Addendum No. 1

Project: Expand Hangar 2003 Apron
FWACAA Project No. AF25-08

CHA Project No.: 098067.000

Date: July 11, 2025

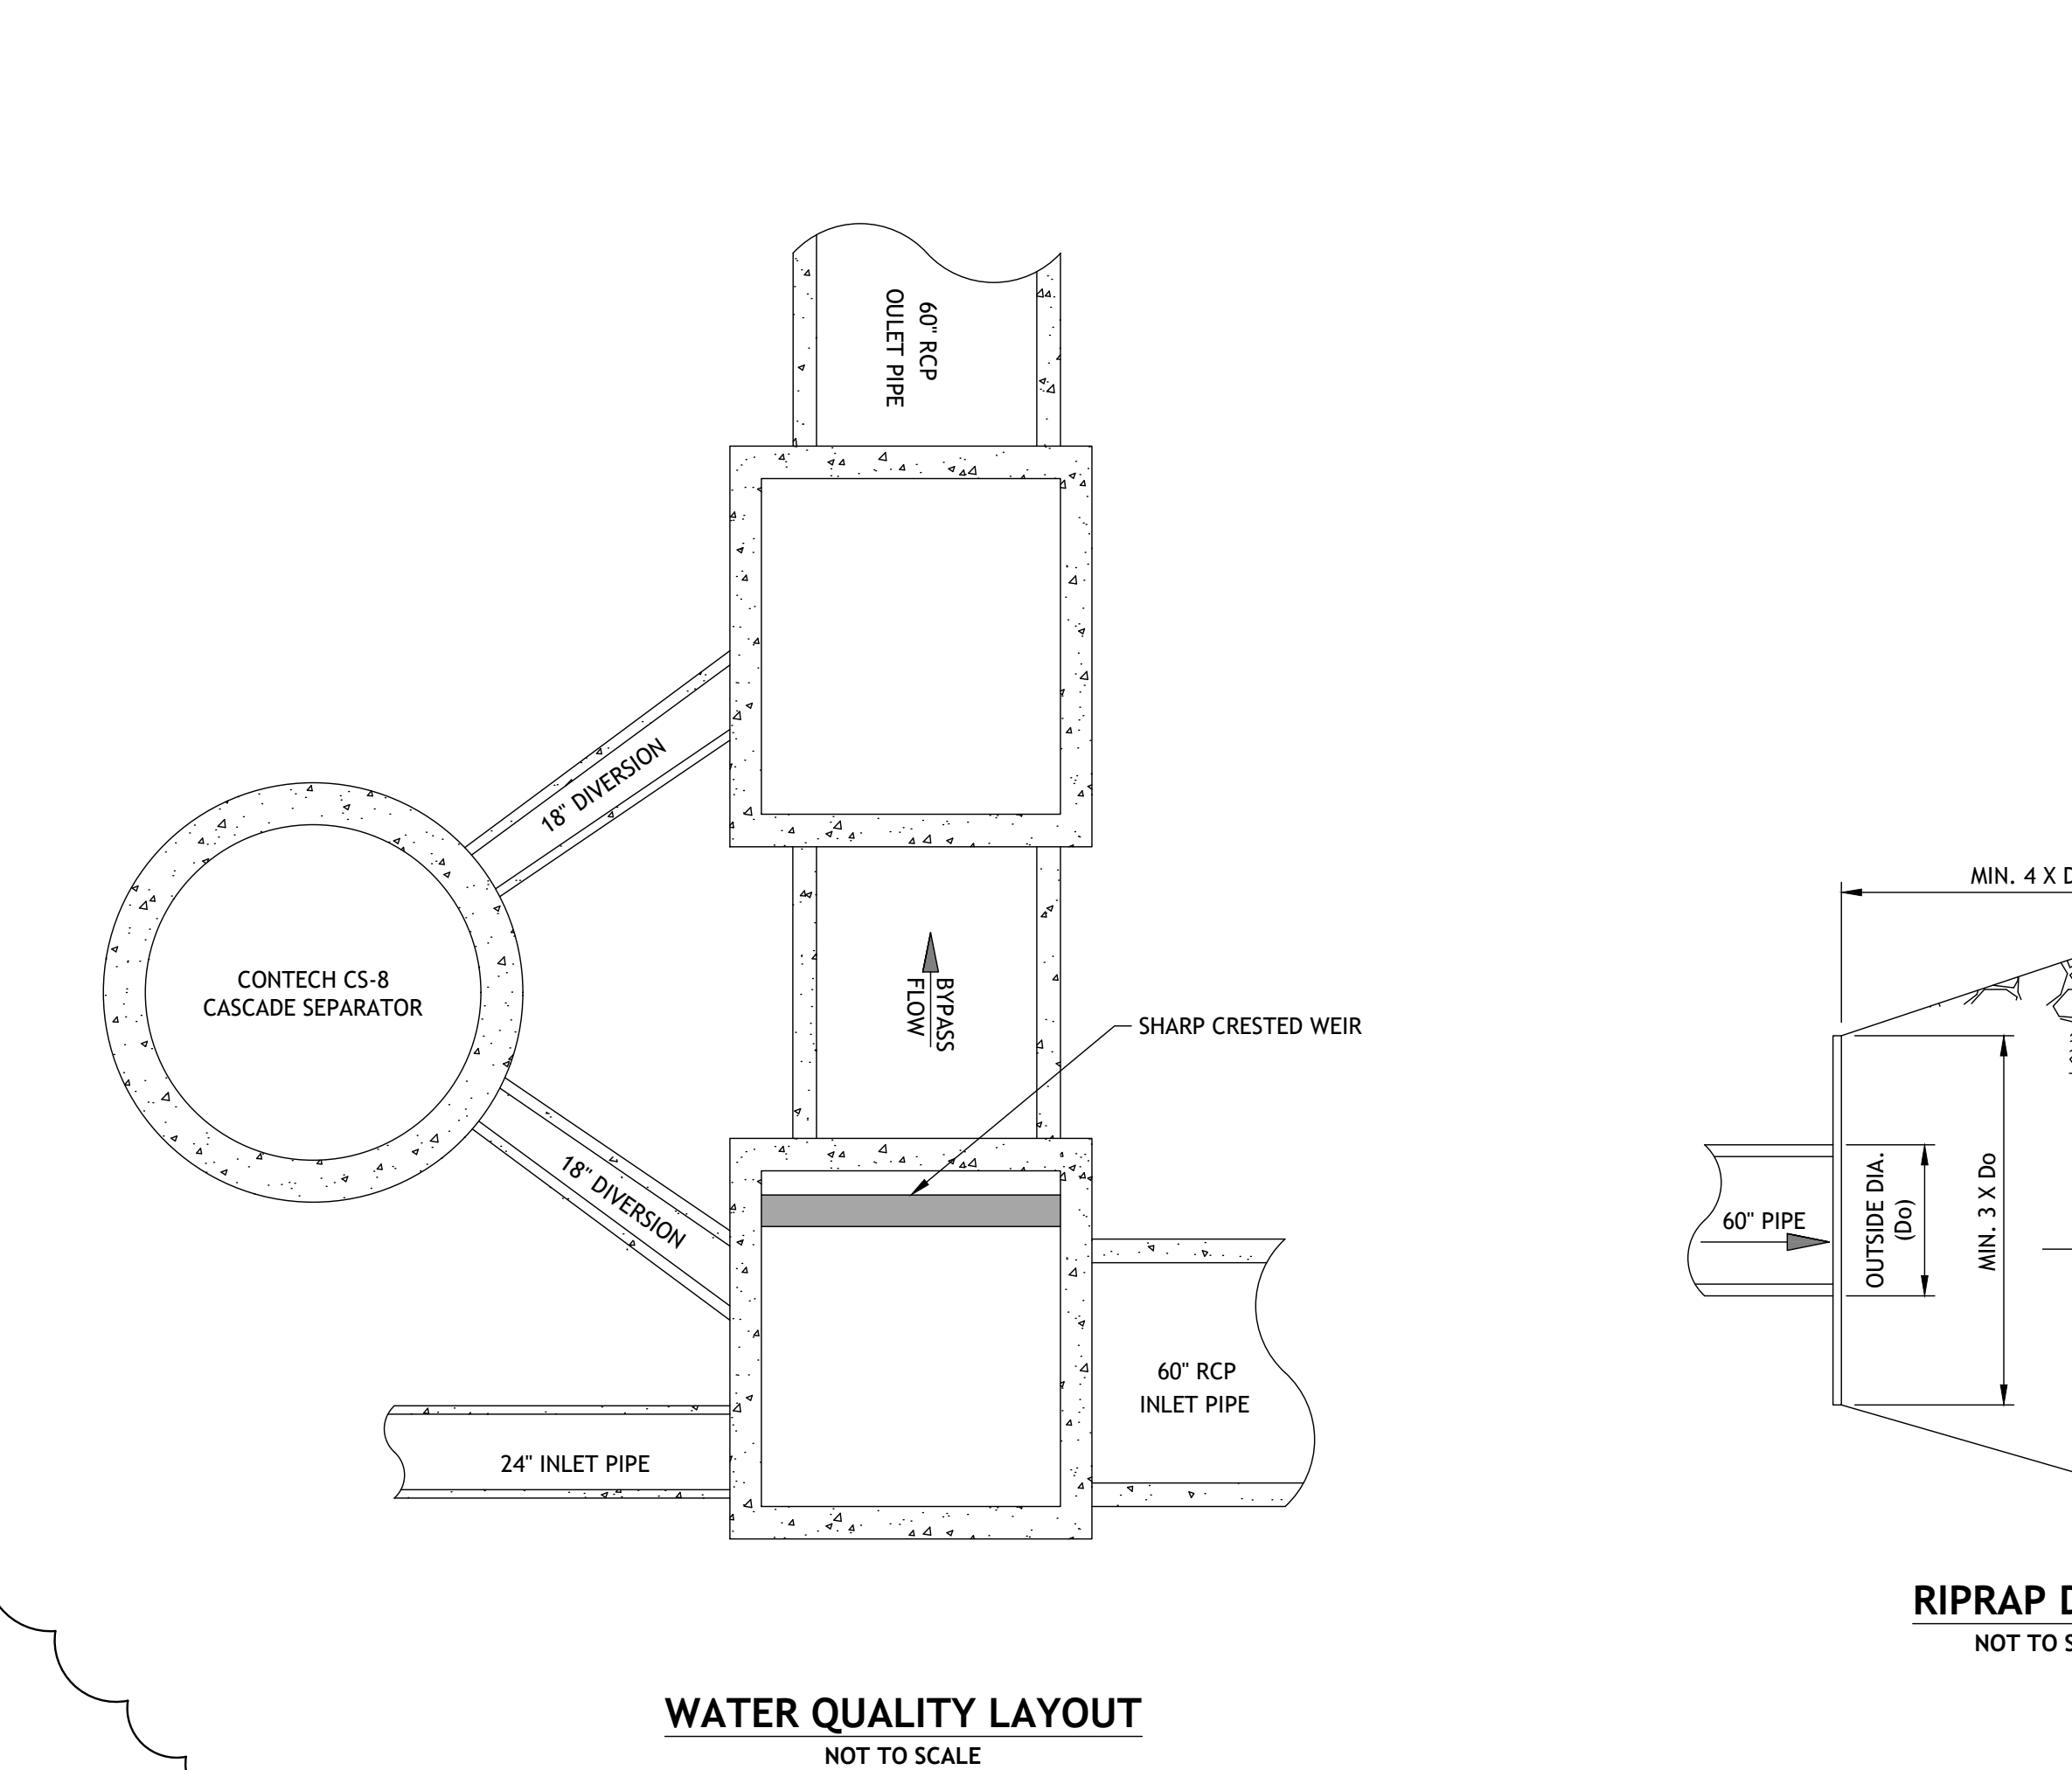
Reissued: 30" RCP denoted between Structure No.'s ST-CB-06 and ST-CB-09 has been revised to be 36" RCP.
